# Minnesota Public Utilities Commission

## Staff Briefing Papers

Company: Otter Tail Power Company

In the Matter of Otter Tail Power Company's Application for 2014-2028  
Integrated Resource Plan Approval

**Figure 5-12: Preferred Plan CO<sub>2</sub> Emissions and the CO<sub>2</sub> reduction Goal**

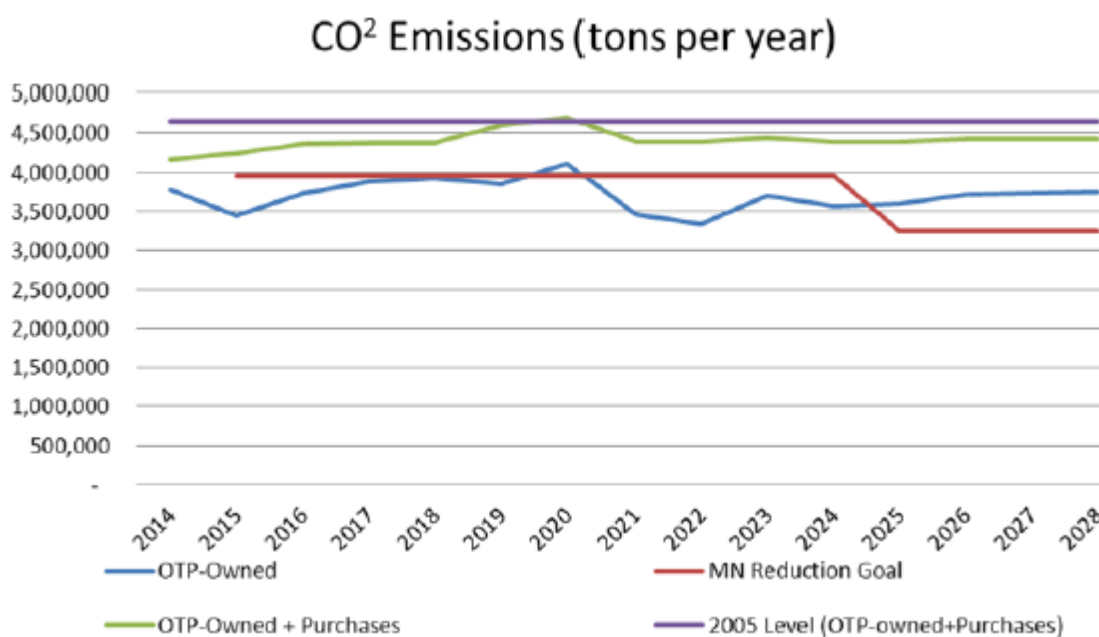
Otter Tail's Preferred Plan does not reduce GHG emissions by an amount commensurate with 216H.02. In fact, as shown in Figure 5-12 of Otter Tail's Petition, below, Otter Tail's Preferred Plan increases total CO<sub>2</sub> emissions relative to 2014 and reduces CO<sub>2</sub> emissions relative to 2005 by about 6 percent by 2025.<sup>25</sup> As shown in Figure 5-12, Otter Tail estimates its 2005 emissions level was 4.6 million tons CO<sub>2</sub>, indicated by the purple line. Its Preferred Plan CO<sub>2</sub> emissions level is approximately 4.5 million tons by the end of the planning period.

Looking closely at years 2019-2020, CO<sub>2</sub> emissions shown by the green line, the Preferred Plan, actually increase above 2005 CO<sub>2</sub> levels (the flat, purple line) before Hoot Lake Plant is ultimately retired at the end of 2020. Then, as a result of higher utilization of Big Stone and Coyote Station, much greater utilization at Solway, and the addition of a natural gas unit in 2021, Otter Tail’s system CO<sub>2</sub> emissions increase above 2014 levels by the end of the planning period.

Of particular importance, Staff believes Otter Tail’s system CO<sub>2</sub> emissions must be considered on the basis of emissions from owned plus purchased generation. For the most part, this is because the GHG progress reports which the Minnesota Pollution Control Agency submits to the Legislature “include net imported electricity in Minnesota.”<sup>26</sup> Thus, reporting GHG emissions from out-of-state sources, including market purchases, would be consistent with PCA’s methodology. Secondly, Otter Tail expects to purchase around 15-20 percent of its energy from the market on average. It would be misleading to exclude purchases from the calculation, since market purchases are the second-largest contributor of the Company’s energy needs, after coal.
